ADDENDUM NO. 2

Life Sciences Collaboration
 1910 N. Antelope Valley
 Parkway
 Lincoln, Nebraska
 TCEP No.: 716-002-12
 Davis Design.: 12-0077
 BVH No.: L12018.unl
 November 27, 2013

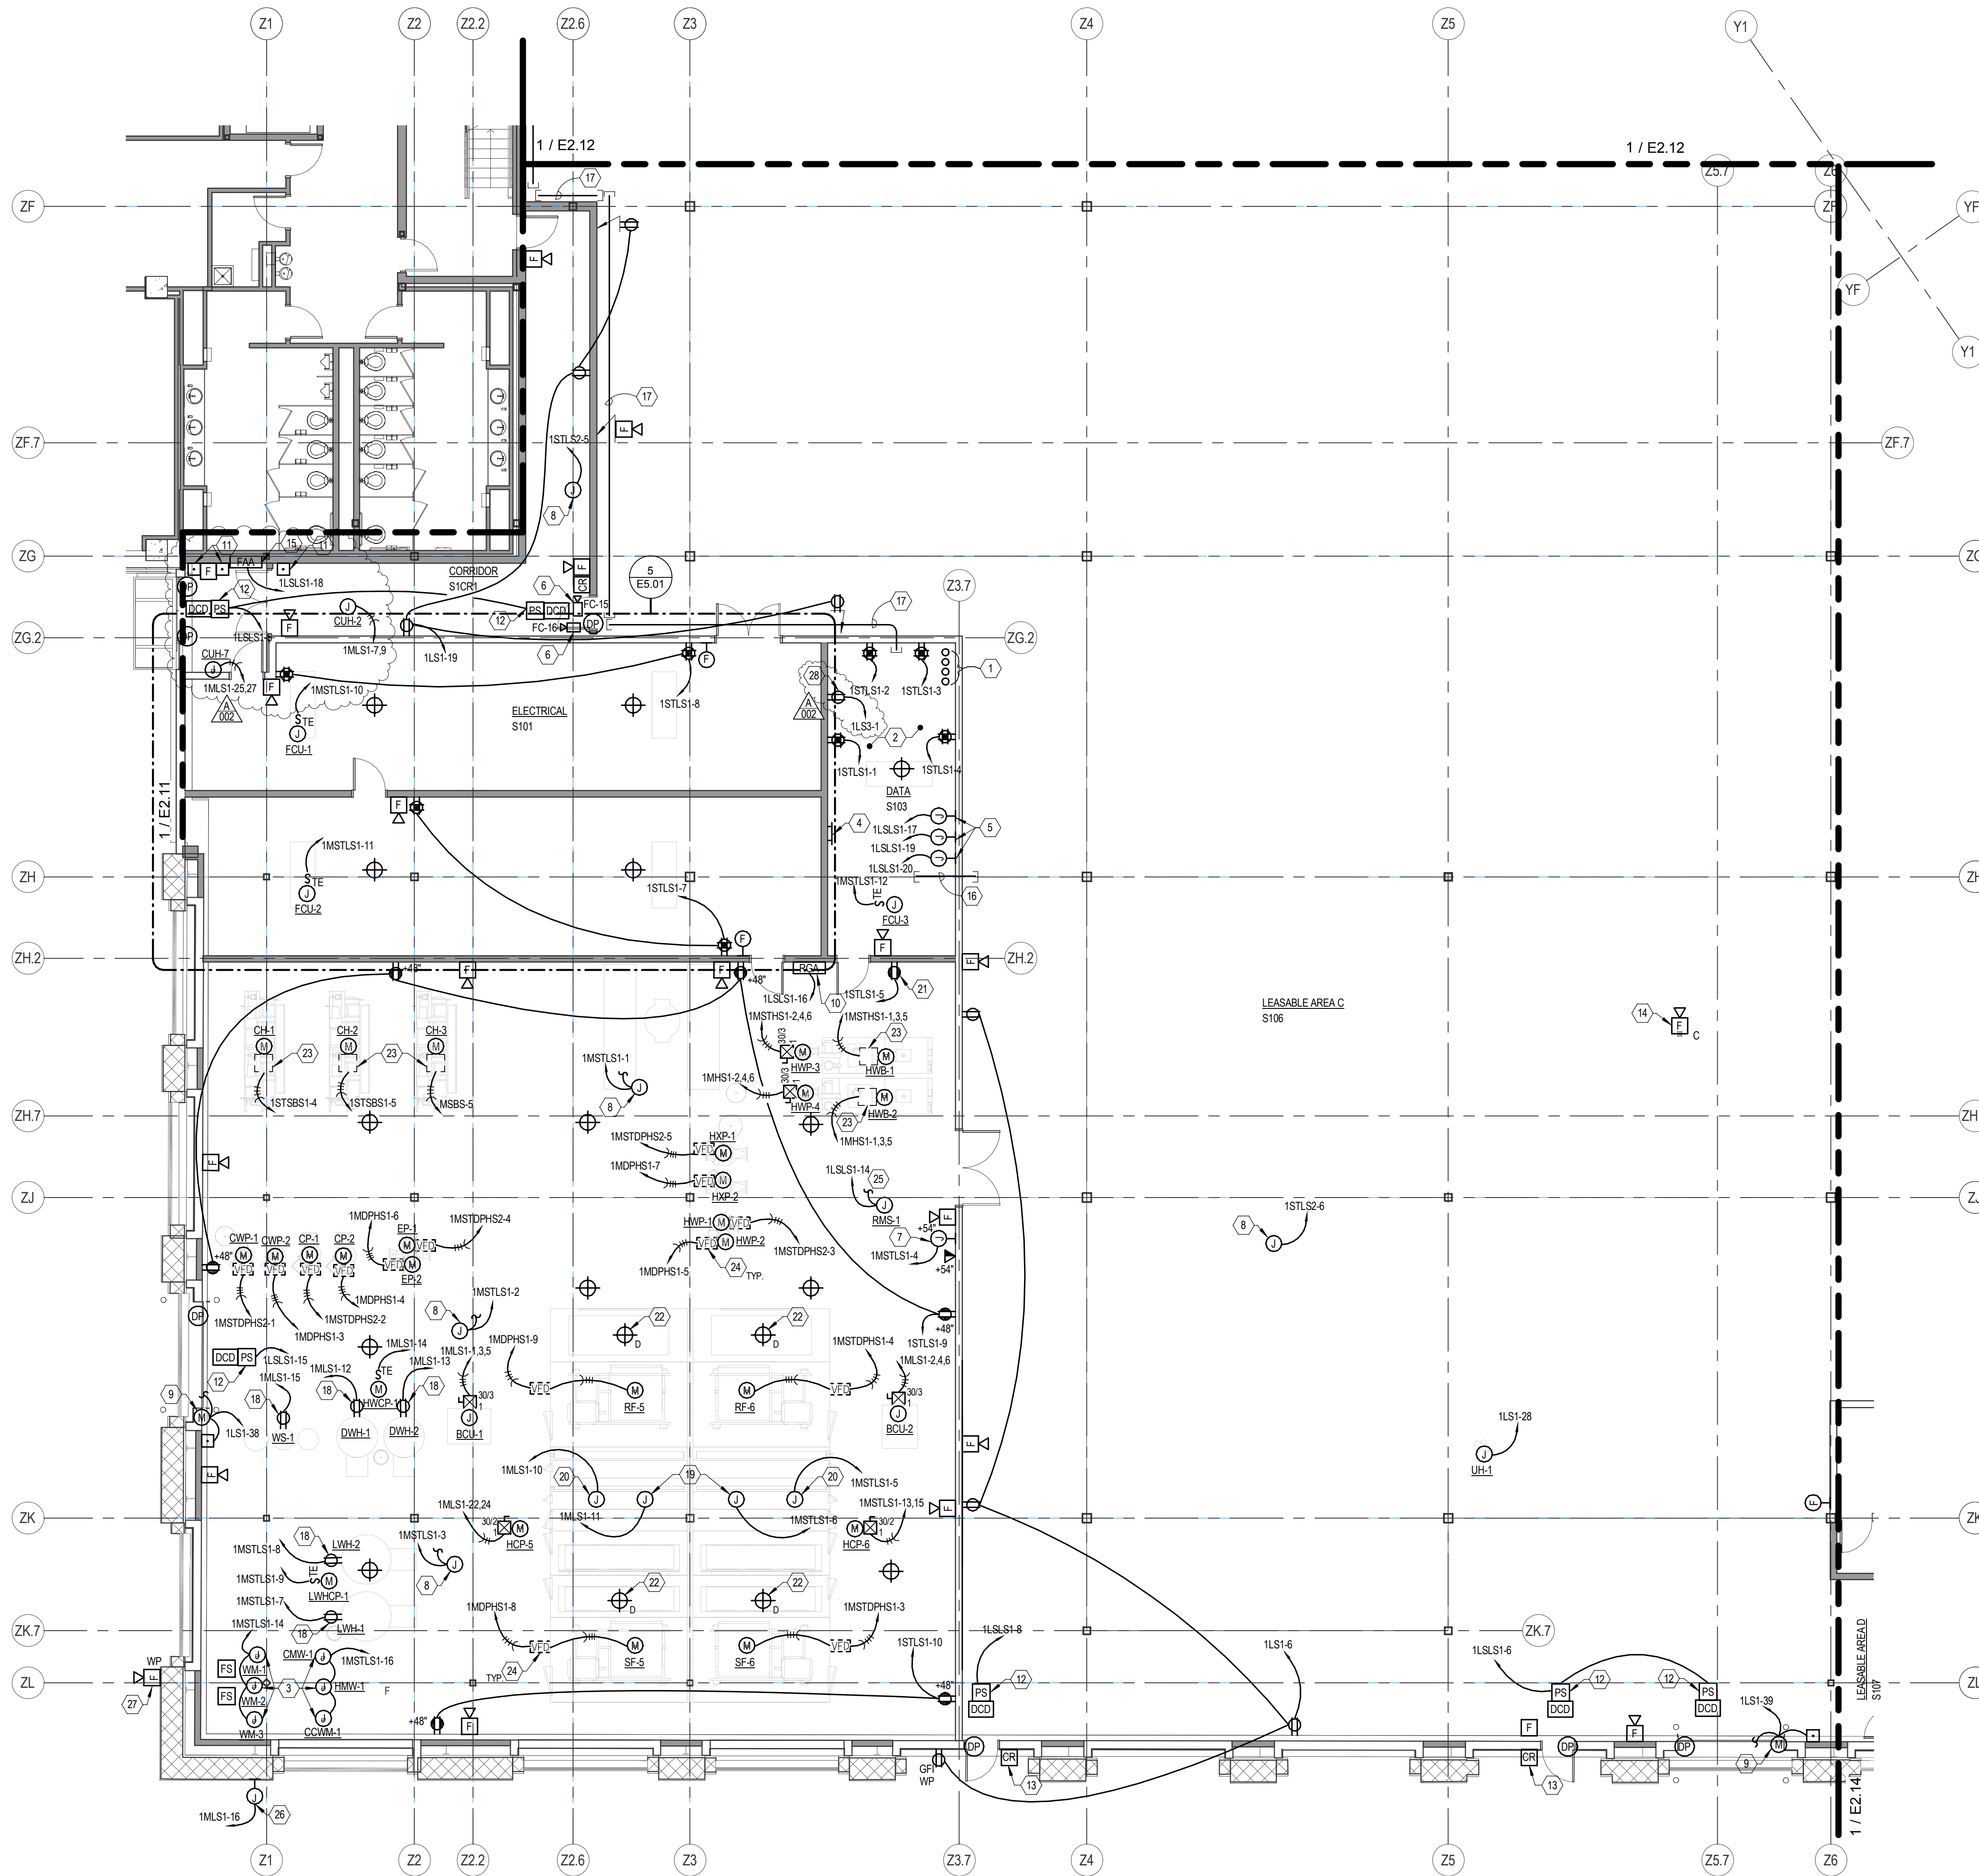
Item 2-73: Sheet E2.13 – First Floor Power & Auxiliary Systems Plan – Area ‘C’

Various changes to accommodate new vestibule, including addition of CUH-7. Add duplex receptacle in Data Room. See re-issued sheet E2.13 for changes.
